Subject: NCR No. ZPMC-0359

QUALITY ASSURANCE -- NON-CONFORMANCE REPORT

Report No: NCR-000385

Reference Description: Missed MT Indications on West Tower, Lift 1, 28m Fit Lug welds

项目名称 Project Name:	美国海湾大桥 SFOBB	部件图号 Drawing No.:	WSD1-A115D/J	报告编号 Report No.:	T-CWR278
合同号 Contract No.:	04-0120F4	部件名称 Item Name:	Tower(W) 1 st lifting	NDT 报告编号 NDT Report No.:	T787-MT-5974
项目编号 Project No.:	ZP06-787

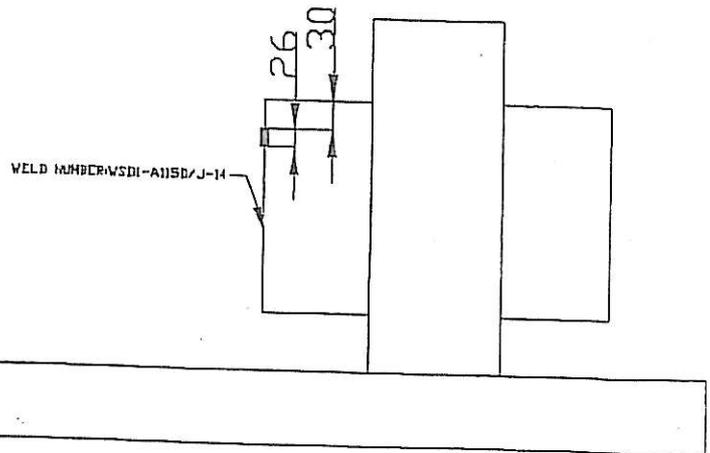
在对WSD1-A115D/J-14检测时, 发现1处纵向裂纹, L=26mm Y=30mm

One longitudinal crack was found by use of MT on WSD1-A115D/J-14.

1. QC shall monitor and direct the welder and the grinder doing the repair operation.
 2. Preheat before gouging; the temperature shall be at least 65°C.

3. Gouge the weld to remove identified defects.
 4. Joint details shall refer to the approved WPS repair.
 5. Grind the gouged areas to a smooth and shiny surface.

6. Verify with VT and MT to ensure no defects remain in the weld joint prior to welding.
 7. QC shall monitor all welding passes being deposited.
 8. QC shall ensure all slag has been removed prior the deposition of next pass.

9. Preheat and maintain interpass temperature control in accordance with the WPS.
 10. Blend the weld repaired areas into the adjacent weld or base metal by grinding.

11. Perform VT, MT and UT NDT inspection to the repaired areas.
1. 在返修过程中, QC 应该监控和指导焊工和打磨工;
 2. 碳刨之前必须先进行预热, 温度不低于 65° C;
 3. 碳刨去除缺陷;
 4. 缺陷被完全消除后, 必须准备一个正确的接头型式, 具体接头型式请参见对应的修补焊接工艺规程(WPS);

项目名称 Project Name:	美国海湾大桥 SFOBB	部件图号 Drawing No.:	WSD1-A115D/J	报告编号 Report No.:	T-CWR279
合同号 Contract No.:	04-0120F4	部件名称 Item Name:	Tower(W) 1 st lifting	NDT 报告编号 NDT Report No.:	T787-MT-5975
项目编号 Project No.:	ZP06-787

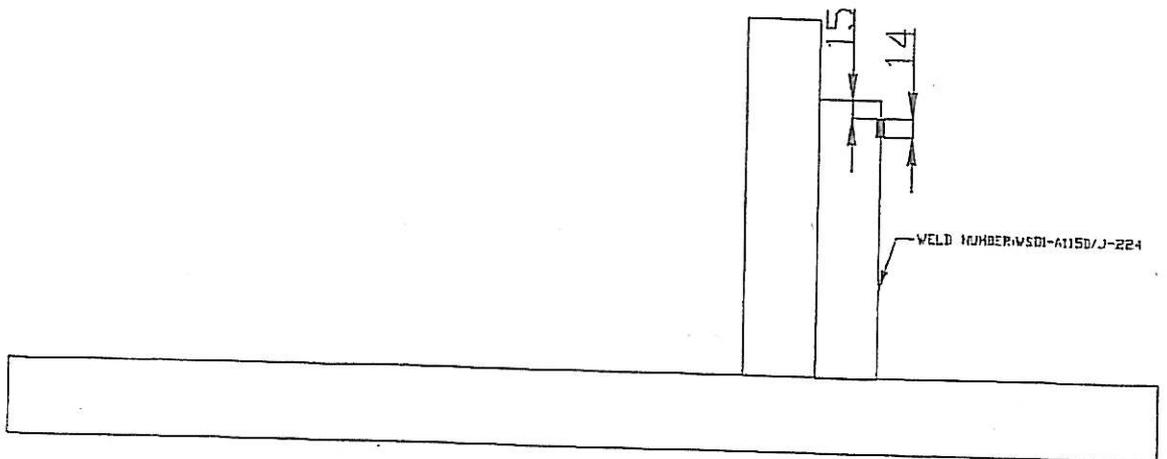
在对WSD1-A115D/J-224检测时, 发现1处纵向裂纹。L=14mm Y=15mm

One longitudinal crack was found by use of MT on WSD1-A115D/J-224.

1. QC shall monitor and direct the welder and the grinder doing the repair operation.
 2. Preheat before gouging; the temperature shall be at least 65°C.

3. Gouge the weld to remove identified defects.
 4. Joint details shall refer to the approved WPS repair.
 5. Grind the gouged areas to a smooth and shiny surface.

6. Verify with VT and MT to ensure no defects remain in the weld joint prior to welding.
 7. QC shall monitor all welding passes being deposited.
 8. QC shall ensure all slag has been removed prior the deposition of next pass.

9. Preheat and maintain Interpass temperature control in accordance with the WPS.
 10. Blend the weld repaired areas into the adjacent weld or base metal by grinding.

11. Perform VT, MT and UT NDT inspection to the repaired areas.
-
1. 在返修过程中, QC 应该监控和指导焊工和打磨工;
 2. 碳刨之前必须先进行预热, 温度不低于 65° C;
 3. 碳刨去除缺陷;
 4. 缺陷被完全消除后, 必须准备一个正确的接头型式, 具体接头型式请参见对应的修补焊接工艺规程(WPS);

项目名称 Project Name:	美国海湾大桥 SFOBB	部件图号 Drawing No.:	WSD1-A115DJJ	报告编号 Report No.:	T-CWR 280
合同号 Contract No.:	04-0120F4	部件名称 Item Name:	Tower(W) 1 st lifting	NDT 报告编号 NDT Report No.:	T787-MT-5975
项目编号 Project No.:	ZP06-787

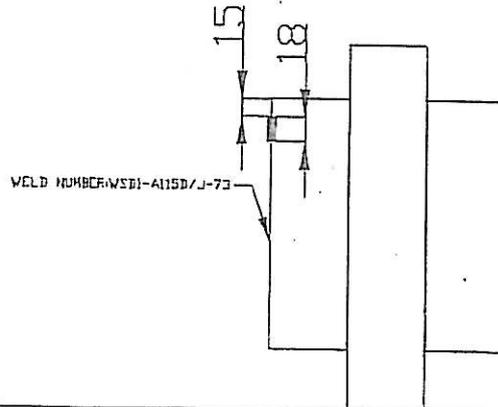
在对WSD1-A115DJJ-73检测时, 发现1处纵向裂纹。L=18mm Y=15mm

One longitudinal crack was found by use of MT on WSD1-A115DJJ-73.

1. QC shall monitor and direct the welder and the grinder doing the repair operation.
 2. Preheat before gouging; the temperature shall be at least 65°C.

3. Gouge the weld to remove identified defects.
 4. Joint details shall refer to the approved WPS repair.
 5. Grind the gouged areas to a smooth and shiny surface.

6. Verify with VT and MT to ensure no defects remain in the weld joint prior to welding.
 7. QC shall monitor all welding passes being deposited.
 8. QC shall ensure all slag has been removed prior the deposition of next pass.

9. Preheat and maintain interpass temperature control in accordance with the WPS.
 10. Blend the weld repaired areas into the adjacent weld or base metal by grinding.

11. Perform VT, MT and UT NDT inspection to the repaired areas.
1. 在返修过程中, QC 应该监控和指导焊工和打磨工;
 2. 碳刨之前必须先进行预热, 温度不低于 65° C;
 3. 碳刨去除缺陷;
 4. 缺陷被完全消除后, 必须准备一个正确的接头型式, 具体接头型式请参见对应的修补焊接工艺规程(WPS);

项目名称 Project Name:	美国海湾大桥 SFOBB	部件图号 Drawing No.:	WSD1-A115D/J	报告编号 Report No.:	T-CWR 281
合同号 Contract No.:	04-0120F4	部件名称 Item Name:	Tower(W) 1 st lifting	NDT 报告编号 NDT Report No.:	T787-MT-5975
项目编号 Project No.:	ZP06-787

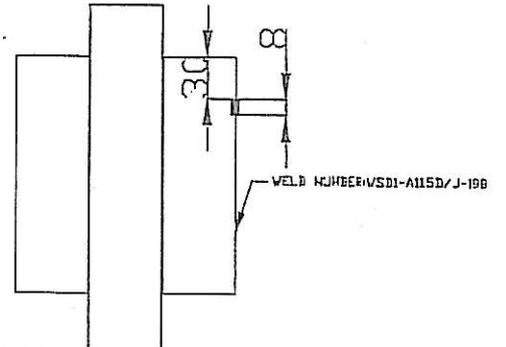
在对WSD1-A115D/J-198检测时, 发现1处纵向裂纹. L=8mm Y=30mm

One longitudinal crack was found by use of MT on WSD1-A115D/J-198.

1. QC shall monitor and direct the welder and the grinder doing the repair operation.
 2. Preheat before gouging; the temperature shall be at least 65°C.

3. Gouge the weld to remove identified defects.
 4. Joint details shall refer to the approved WPS repair.
 5. Grind the gouged areas to a smooth and shiny surface.

6. Verify with VT and MT to ensure no defects remain in the weld joint prior to welding.
 7. QC shall monitor all welding passes being deposited.
 8. QC shall ensure all slag has been removed prior the deposition of next pass.

9. Preheat and maintain interpass temperature control in accordance with the WPS.
 10. Blend the weld repaired areas into the adjacent weld or base metal by grinding.

11. Perform VT, MT and UT NDT inspection to the repaired areas.
-
1. 在返修过程中, QC 应该监控和指导焊工和打磨工;
 2. 碳刨之前必须先进行预热, 温度不低于 65°C;
 3. 碳刨去除缺陷;
 4. 缺陷被完全消除后, 必须准备一个正确的接头型式, 具体接头型式请参见对应的修补焊接工艺规程(WPS);
